Subject: LaSalle County Station Units 1 and 2
Response to Request for Additional
Information Concerning Proposed Amendment
to the Technical Specification for Facility
Operating License NPF-11 and NPF-18
NRC Docket Nos. 50-373 and 50-374

The following attachment provides Commonwealth Edison's LaSalle
Station response to the NRC question concerning the expected radiation dose rates
in the Unit 1 and 2 Main Steam Tunnels during power operation.

LaSalle County Station Unit 2 Main Steam Tunnel Dose Rate vs Power

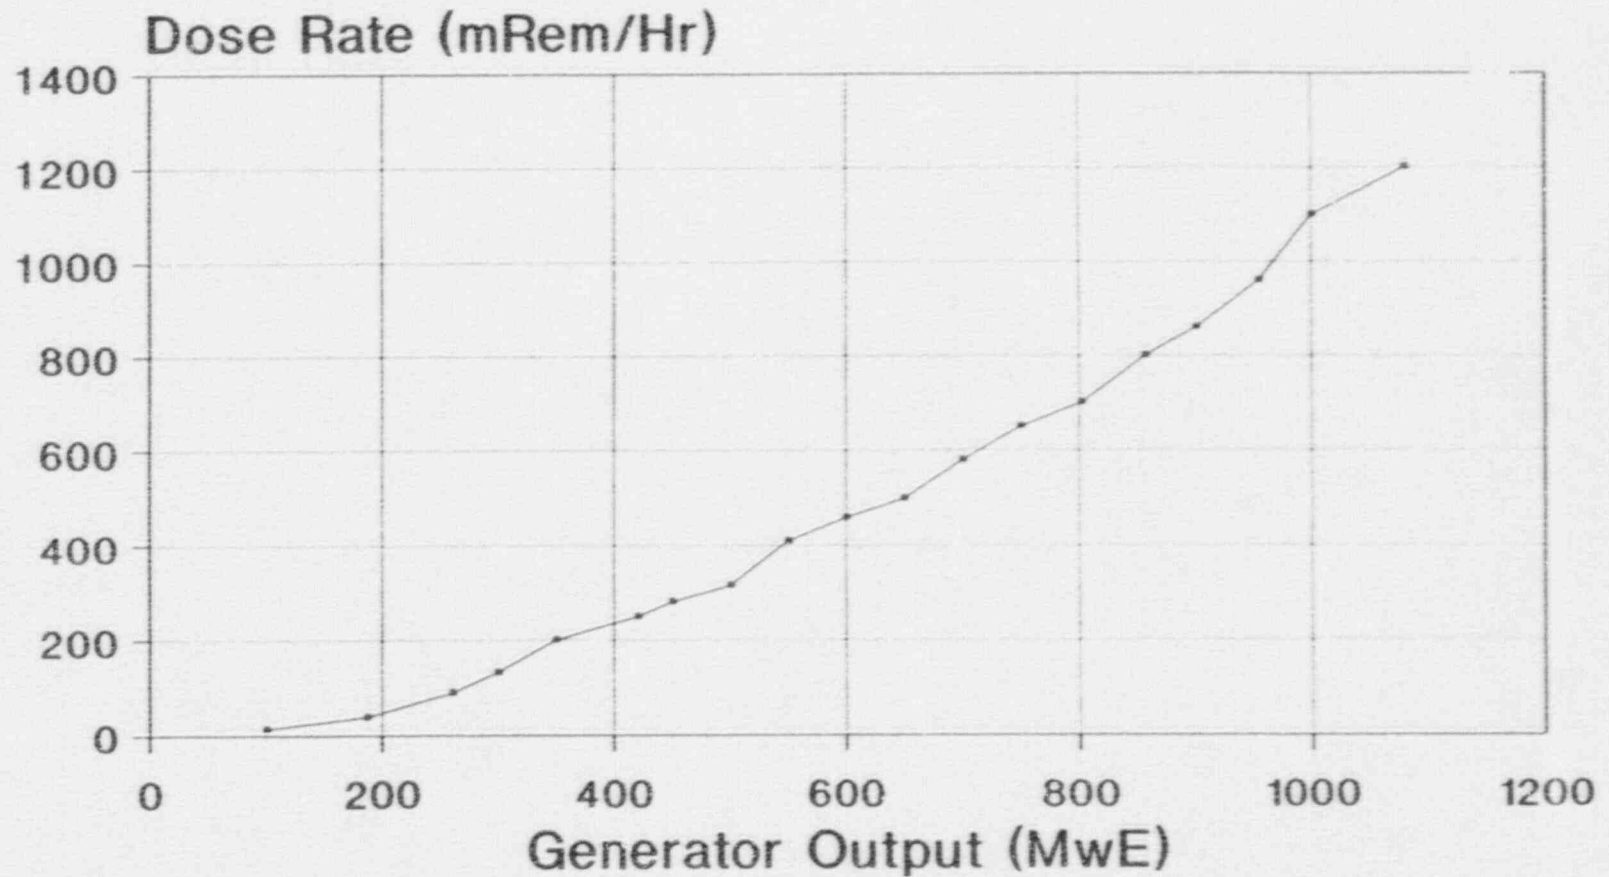
What is the radiation dose rate in the Units 1 and 2 Main Steam Tunnel's (MST) during power operation?

During the Unit 2 Startup Test Program in 1984 a survey of the MST dose rates at various power levels was completed by the station Radiation Protection Department. The dose rates in the MST are due almost entirely to N16 gamma rays. Since, the level of N16 present in the steam in a BWR is a function of reactor power, it can be assumed that this data may also be applied to Unit 1. The data indicates that the dose rate varies directly with power from less than 50 mRem/hour at 100 MWe to 1200 mRem/hour at 1080 MWe (refer to the attached graph of Dose Rate vs. Power).

As can be seen from the data provided, it can be expected that any entries made into the MST while the reactor is at high power, will result in significant man rem accumulations for plant personnel. It should also be noted that during the period of time that the reactor building ventilation system is shutdown it is anticipated that the MST tunnel temperatures will exceed 150°F. These elevated temperatures will help to create a hostile work environment in the MST that will add to the danger of performing periodic inspections.
